RE: ENGINEER'S CERTIFICATION FOR MICROTEL INN (K-9/D-10) ENGINEER'S
CERTIFICATION DATED 5/3/99.

RE: REVISED CONCEPTUAL DRAINAGE PLAN FOR MICROTTEL INN @ AVALON
(K9-D10) REVISION DATED 7/8/98

RE: REVISED DRAINAGE PLAN FOR MICROTTEL INN @ AVALON (K9-D10)
REVISION DATED 9/21/98

AS-BUILT DRAINAGE PLAN FOR MICROTREL INN AT 9910 AVALON RD. NW

REVISION OF
A PROPOSED GRADING AND DRAINAGE PLAN
FOR
MICROTREL INN
(AVOLON ROAD N.W.)
ALBUQUERQUE, NEW MEXICO
SEPTEMBER, 1998
(REVISED: 10-20-98)

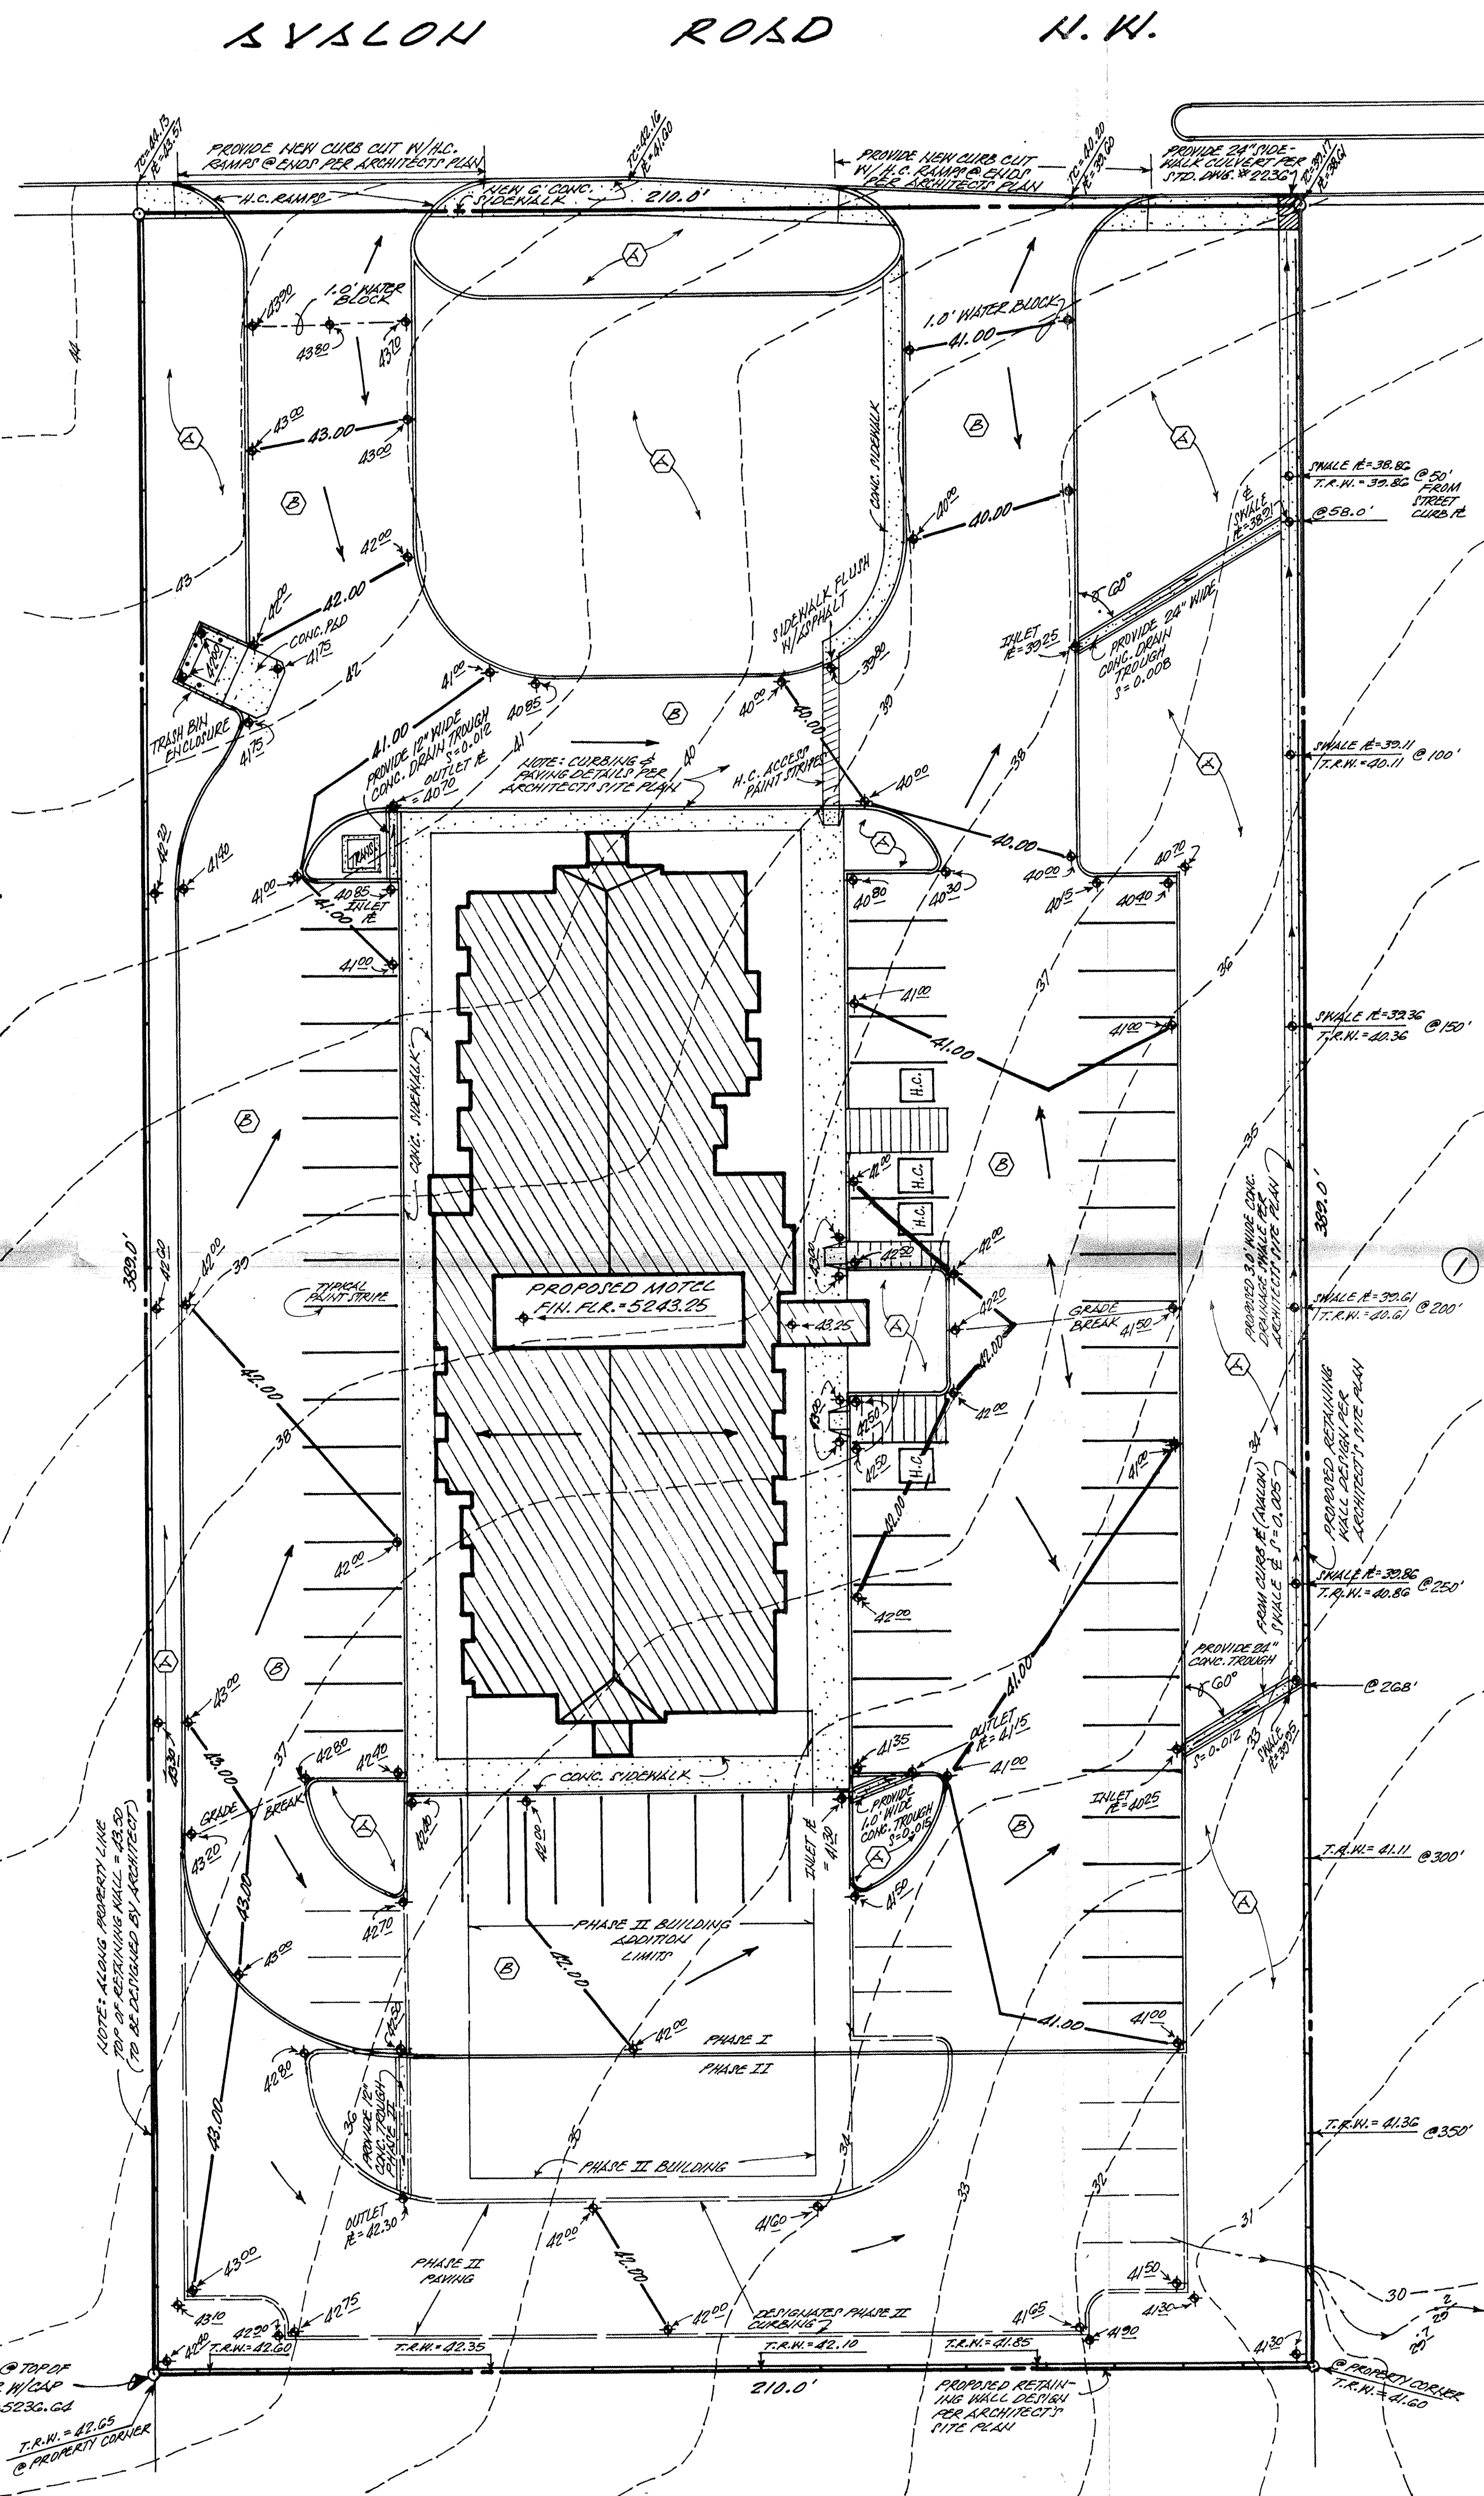
Please be advised that the following concerns must be addressed prior to Building Permit release:

1. One foot water block at the west drivepad.
2. Hydraulics for the proposed 24" inch trough.
3. Retaining wall on the east property line.
4. Indicate the size of troughs within the parking areas.

AS-BUILT DRAINAGE PLAN

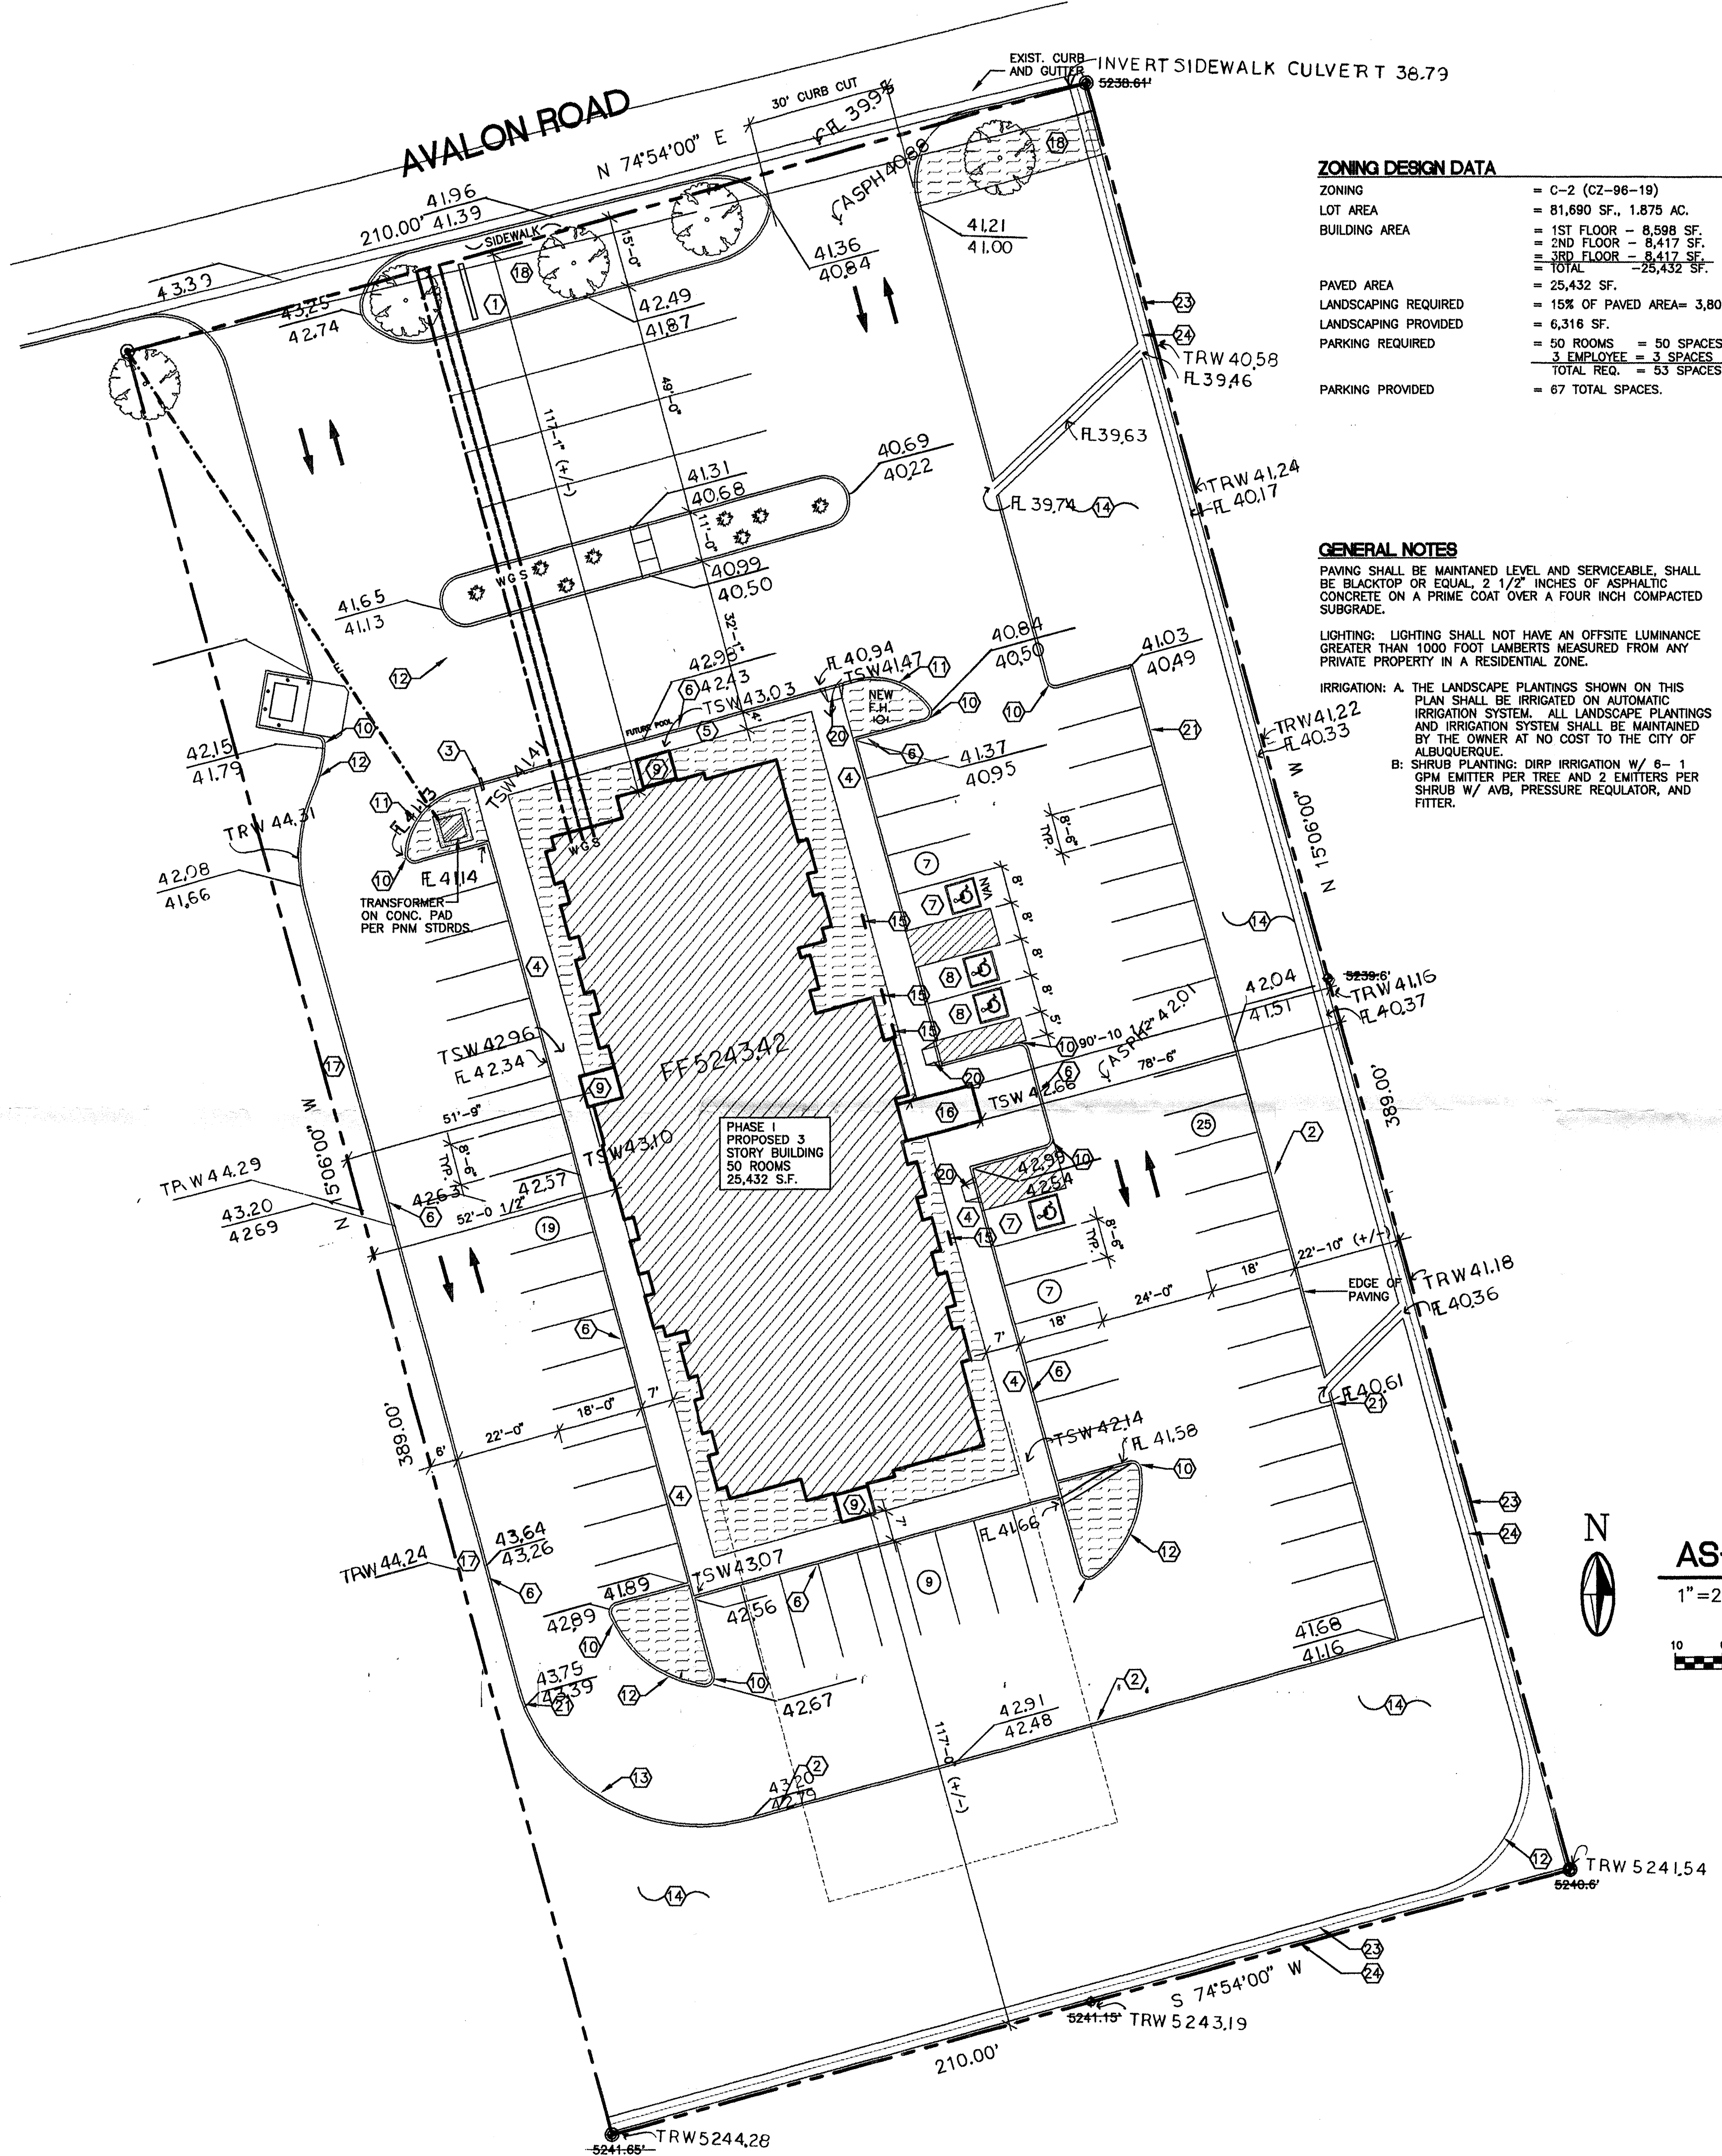
AS INDICATED BY THE AS-BUILT INFORMATION SHOWN HEREON, THE MICROTREL INN @ 9910 AVALON RD. NW HAS BEEN GRADED AND DRAINED IN SUBSTANTIAL COMPLIANCE WITH THE APPROVED PLAN DATED 10/20/98 WITH THE FOLLOWING DEVIATIONS:

- GRADES AT THE WEST SIDE OF BUILDING HAD TO BE RAISED IN ORDER TO LEVEL OFF THE SIDEWALK.
- MINOR GRADE CHANGES IN THE OVERALL SITE.
- MINOR BIRD BATHS WHICH WILL BE CORRECTED BY THE PAVING CO.

THIS DEVIATIONS DO NOT IMPACT THE DRAINAGE CONCEPT IN ANY WAY. THE SITE DRAINAGE WILL FUNCTION IN ACCORDANCE WITH THE PATTERNS ESTABLISHED BY THE APPROVED PLAN. THEREFORE A PERMANENT CERTIFICATE OF OCCUPANCY IS HEREBY RECOMMENDED. THE AS-BUILT INFORMATION SHOWN HEREON WAS OBTAINED BY ME OR UNDER MY SUPERVISION AND IS TRUE AND CORRECT TO THE BEST OF MY KNOWLEDGE AND BELIEF.
